SUBDIVISION COMMITTEE  
METROPOLITAN AREA PLANNING COMMISSION

STAFF REPORT  
(Final Plat)

CASE NUMBER: S/D 92-1 - C.E.C.U. ADDITION

VICINITY MAP:

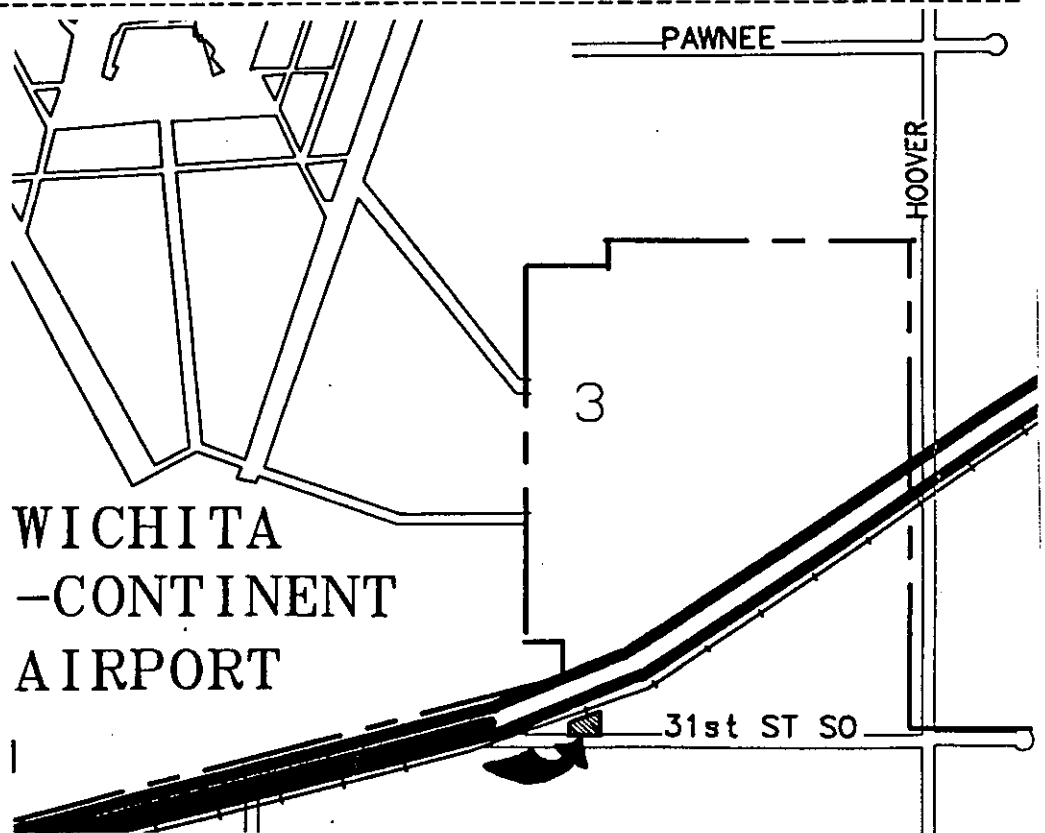
- A. County and/or City Engineering need to verify if water or sanitary sewer are available to this site.
- B. If neither municipal water nor sanitary sewer is available to serve this property, the applicant shall contact the Environmental Health Division of the Health Department to find out what tests may be necessary and what standards are to be met for approval of on-site sewerage facilities and water wells. A memorandum shall be obtained specifying approval.

- C. If water and sanitary sewer are not available, City Engineering needs to indicate if petitions should be required for the future extension of these facilities.

- D. The applicant shall guarantee any drainage improvements required by the platting of this property.
- E. County Engineering needs to indicate if there are any requirements concerning paving of 31st St. S. adjacent to this site.

- G. The applicant shall submit an avigational easement covering all of subject plat and a restrictive covenant assuring that adequate construction methods will be used to minimize the effects of noise pollution in the habitable structures constructed on subject property.

- H. On the final plat tracing, the face of the plat shall delete the word "complete" from the access control being shown for this plat. At this location 31st St. S. is not considered an arterial and the two openings indicated on the face of the plat may be acceptable. County Engineering needs to comment on this access control. If two openings are allowed, the plattor's text shall be corrected to indicate "shall have access to 31st St. South at 2 locations. . ."

- M. Perimeter closure computations shall be submitted with the final plat tracing. Section 5-101(c).
- N. Recording of the plat within 30 days after approval by the City Council.

- O. The representative from County Engineering should be prepared to comment on the status of the applicant's drainage plan.
